Whitworth Street Planning Comparison

Since planning approval in 2016 the site has been purchased by Vision Manchester Limited. The client has engaged a full design team and RussellWBHO to update the detail design to the required regulations, agree a building contract and construct the development. Through this process a number of design changes are being proposed.

This updated document is being presented to Manchester City Council Planning Department to illustrate and explain the nature and extent of the proposed changes and to seek the Council's formal approval through the necessary planning process.

3.22 Proposed Elevation East

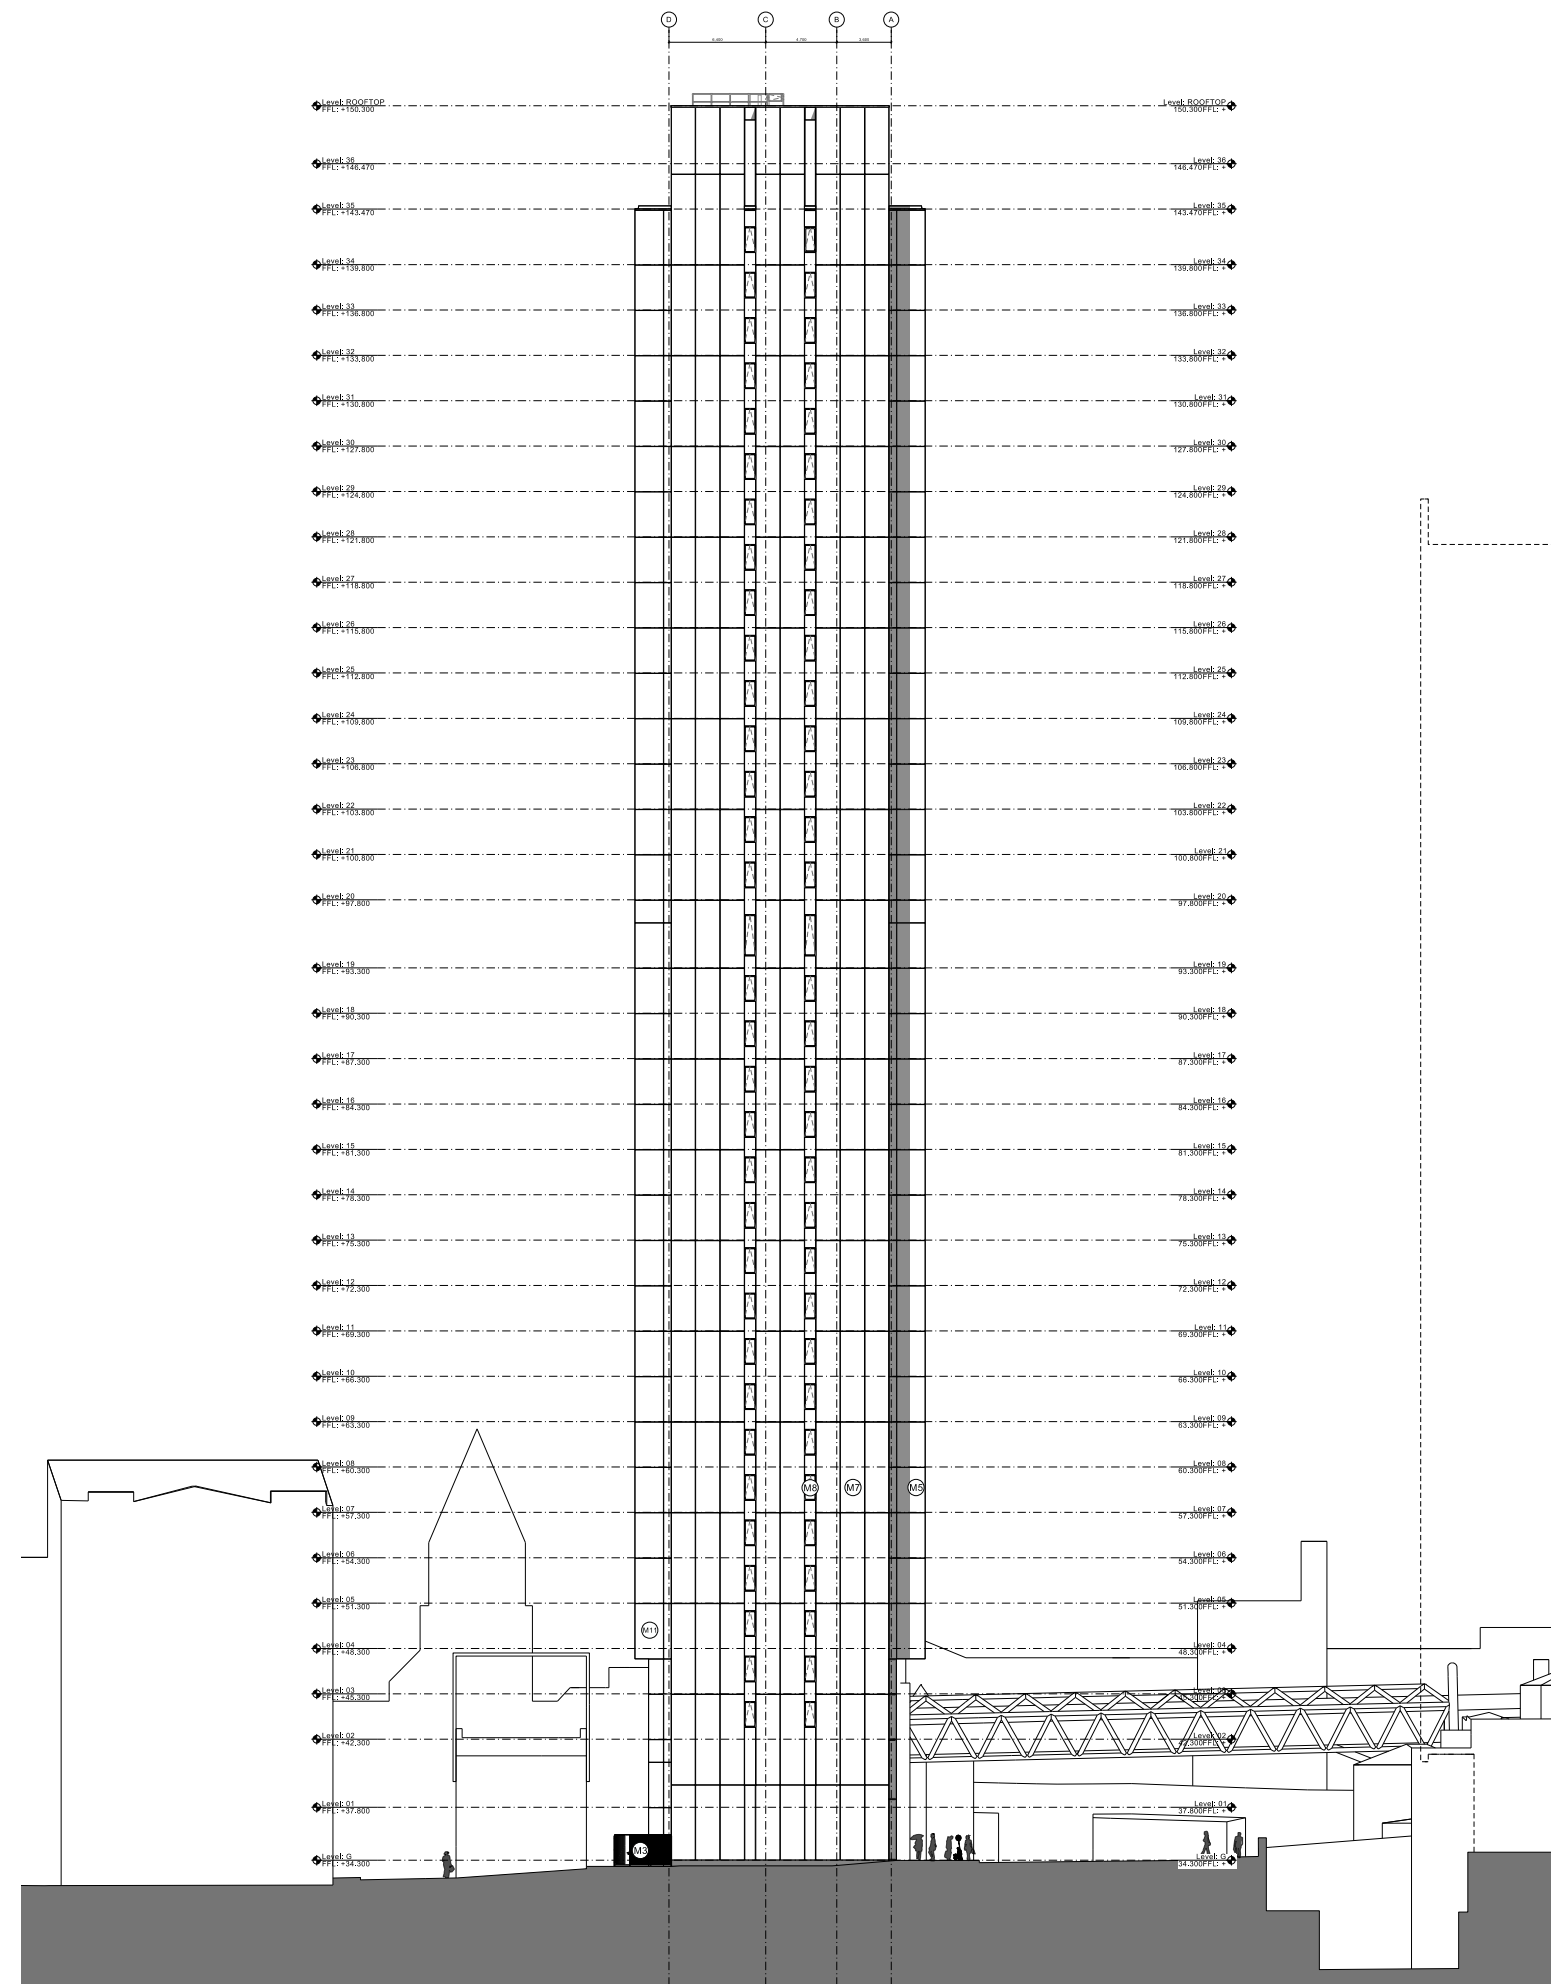
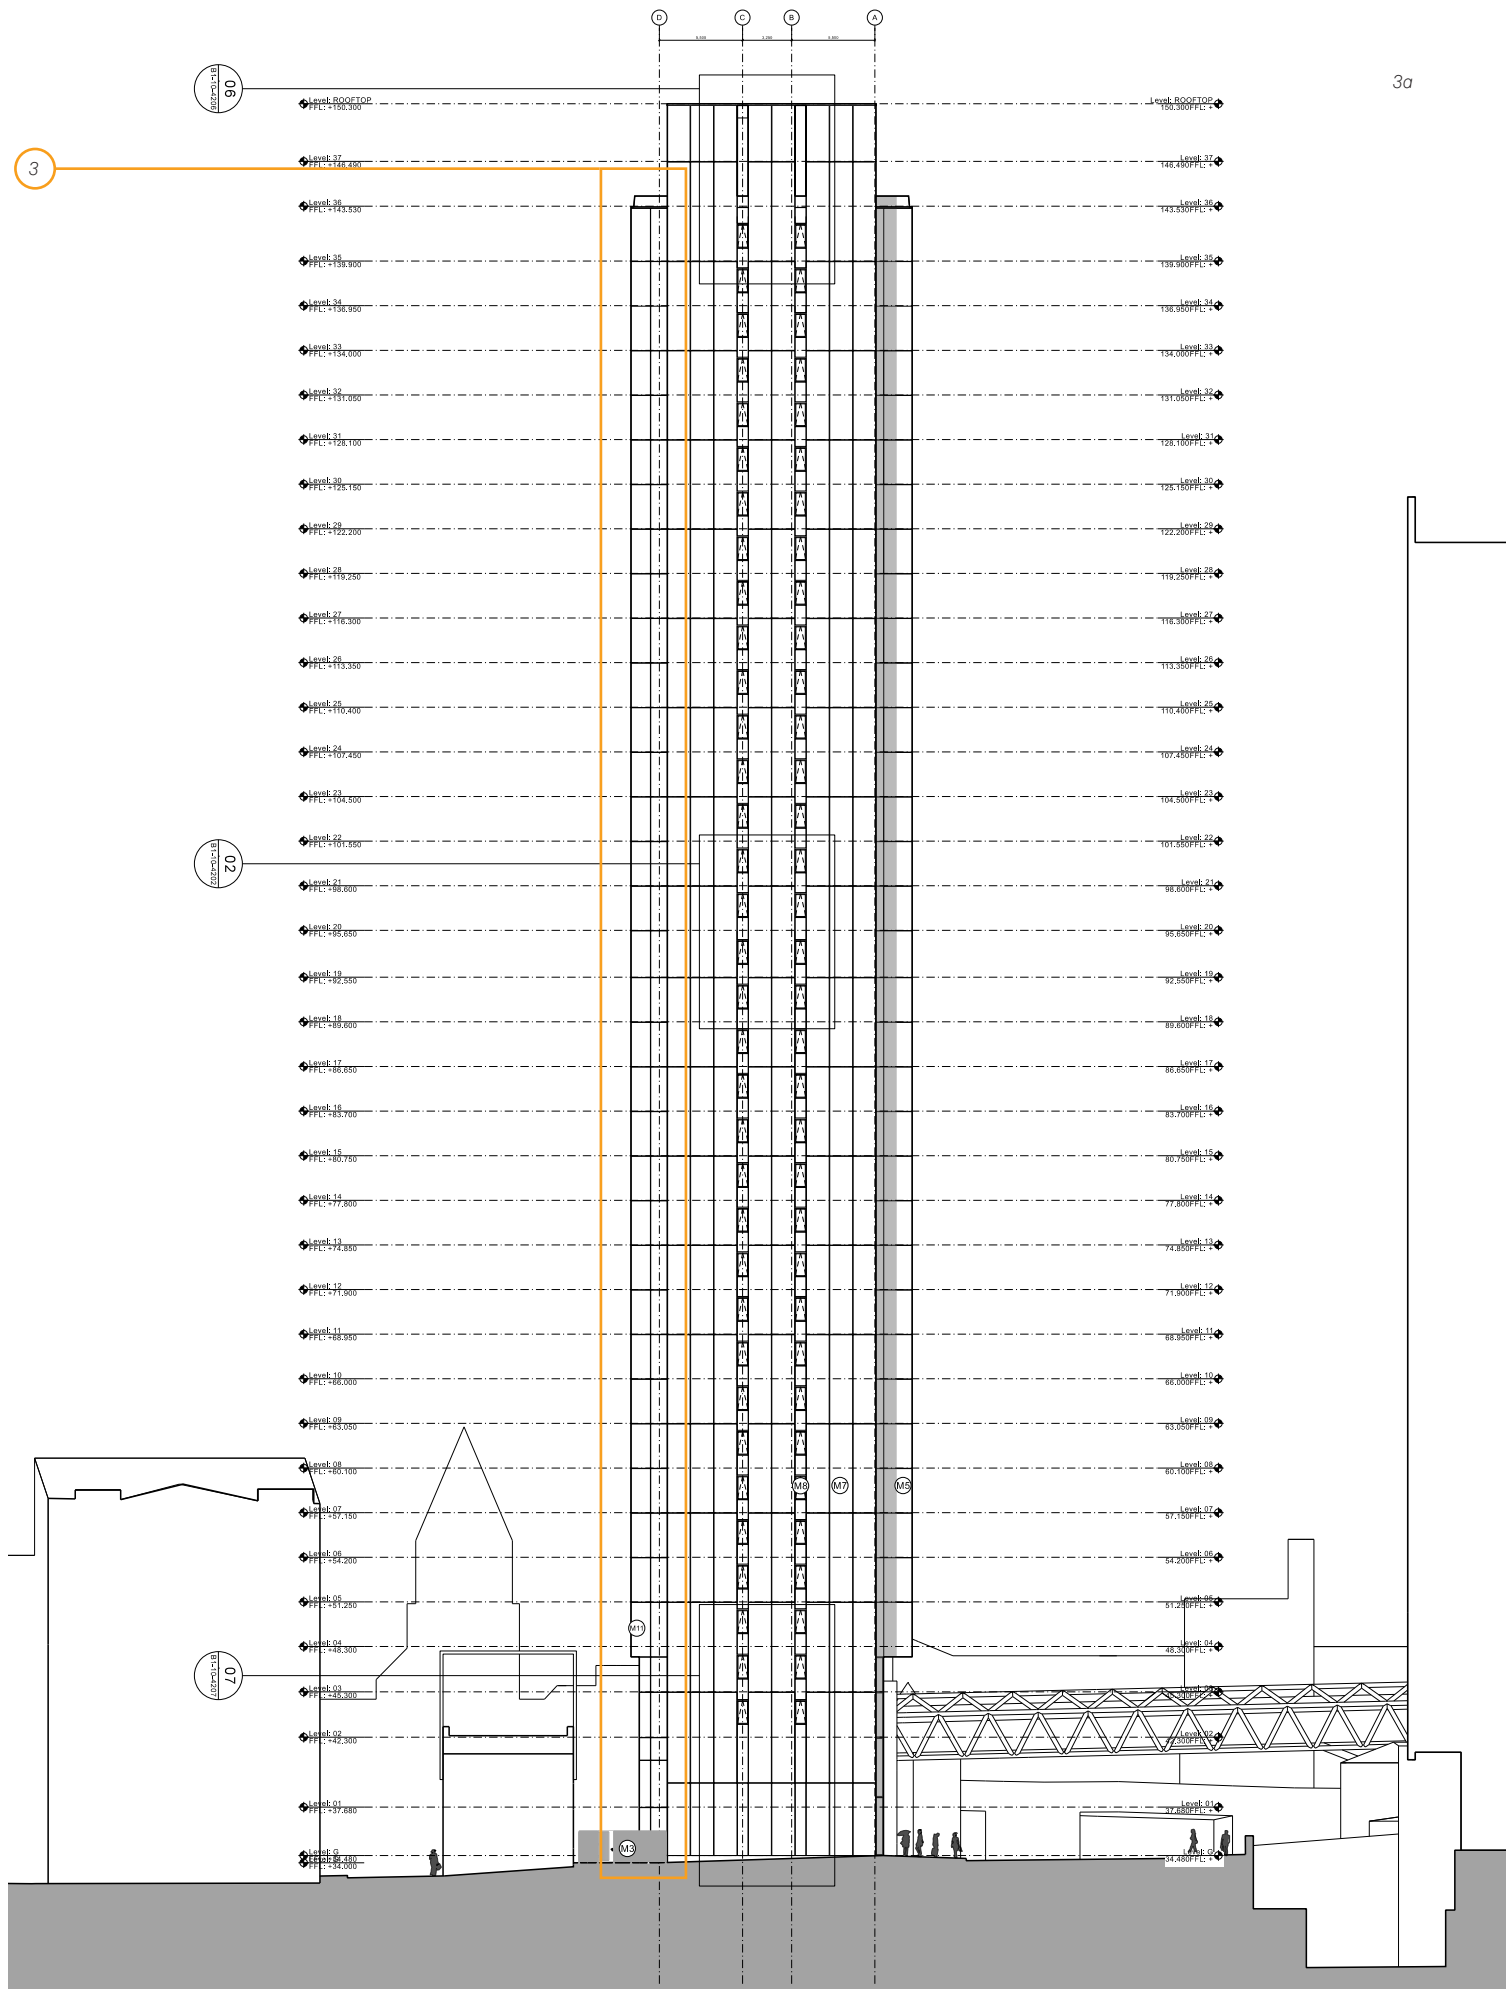
- 1a - Core Repositioned
- 1b - Main body of south facade to match north facade
- 1c - Entrance relocation
- 1d - Form of roof pavilion
- 1e - Apartment & amenity layouts
- 1f - Inclusion of commercial unit & dedicated entrance
- 2a - Reduced floor to floor heights
- 2b - Additional floor
- 2c - 2 no. Guest Beds & 2 no. 1 Bed become 2 no. 2 Bed & 2 no. 3 Bed
- 3 - South 'picture frame' reveal depth reduced by 600mm
